APPLICATION NO.	FILING DATE	FIRST NAMED INVENTOR	ATTORNEY DOCKET NO.	CONFIRMATION NO.
10/710,399	07/08/2004	Min-Jer Lin	LKSP0027USA	4398
27765 7590 05/15/2007 NORTH AMERICA INTELLECTUAL PROPERTY CORPORATION P.O. BOX 506 MERRIFIELD, VA 22116			EXAMINER NGUYEN, DAO H	
			ART UNIT	PAPER NUMBER
			2818	
			NOTIFICATION DATE	DELIVERY MODE
			05/15/2007	ELECTRONIC

Office Action Summary

DETAILED ACTION

FIG. 5

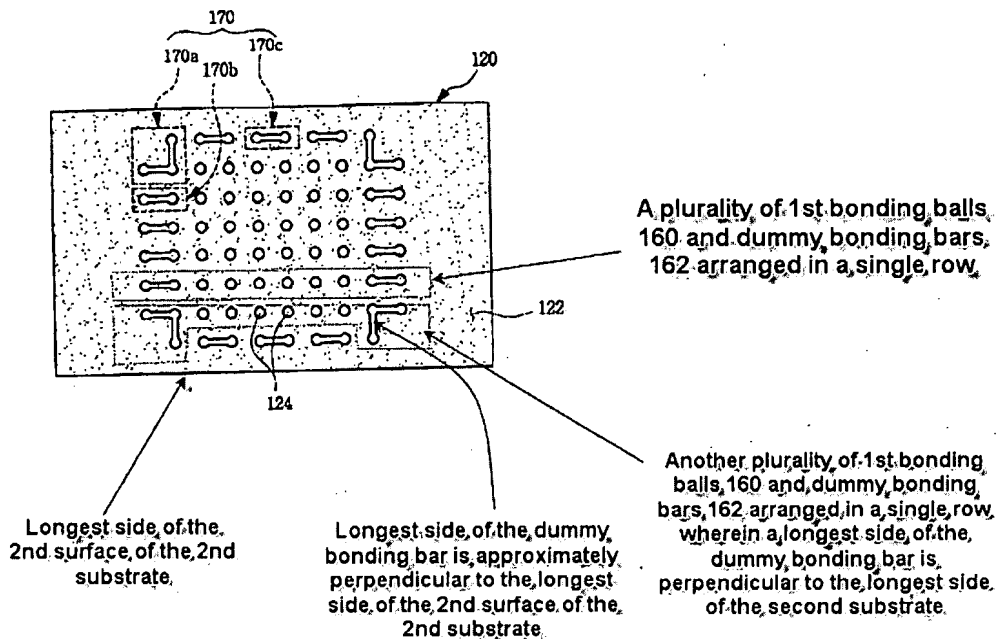
Particularly, Byun does disclose a semiconductor package comprising a plurality of bonding balls 160 and dummy bonding bar(s) 162 arranged in a single row (see attached figure below). Byun does not necessarily disclose the dummy bonding bar(s) 162 having rectangular shape; nevertheless, one of ordinary skills in the art would have recognized that the dummy bonding bar(s) 162 of Byun would have performed the same and/or equal function - that is to prevent the semiconductor package from inclining to one side (see col. 4, lines 9-26 and the remarks in the Office Action mailed 06/09/2006)

- in either a "dumbbell shape" or a rectangular shape. It has been held that where the only difference between the prior art and the claims was a recitation of relative dimensions or shape of the claimed device, and a device having the claimed relative dimensions or shape would not perform differently than the prior art device, the claimed device was not patentably distinct from the prior art device (MPEP §2144.04). It would have been obvious that a mere change in shape of a component is generally recognized as being within the level of ordinary skill in the art.

Besides, though the bonding balls of Byun's invention are arranged in a rectangular array having at least two parallel rows, nowhere in the instant claimed invention states difference. Particularly, the instant claimed invention only recites that the first plurality of bonding balls and the dummy bonding bar are arranged in a single row, while arrangement/configuration of other possible bonding balls/bars are chosen not to describe, or are chosen to describe as being interlaced with the first bonding balls (claims 7, 32), which could also be in a rectangular array (as that taught by Byun).

a plurality of first bonding balls 160 positioned on the second (lower) surface of the second substrate 120 and arranged in a single row (see the attached figure above) along a first direction for connecting the second substrate 120 to the first substrate 150, wherein the first direction is parallel to a long side of the second surface; and

at least a bonding bar 162 positioned on the second surface of the second substrate 120 and arranged in the single row with the first bonding balls 160 (see the attached figure above) for connecting the second substrate 120 to the first substrate 150 and preventing the semiconductor package with the single row of the first bonding balls 160 and the bonding bar 162 from inclining to one side (the bonding bar or connection terminal 162 is large, thereby improving the join force between the first substrate 150 and the second substrate 120, thereby improving the solder joint reliability of the surface mount package (col. 4, lines 9-26); therefore, it is inherently preventing the package from inclining to one side)), wherein the bonding bar 162 and the first bonding balls 160 are arranged in the single row (figs. 4, 5). See also the above remarks.

Regarding claims 3 and 28, Byun discloses the semiconductor package wherein the longest side of the dummy bonding bar 170a is approximately perpendicular to the long side of the second surface for preventing the semiconductor package from inclining. See fig. 5.

Regarding claim 27, Byun discloses the semiconductor package wherein the second surface has a rectangular shape, and the first direction is parallel to a long side of the second surface. See figs. 4, 5.
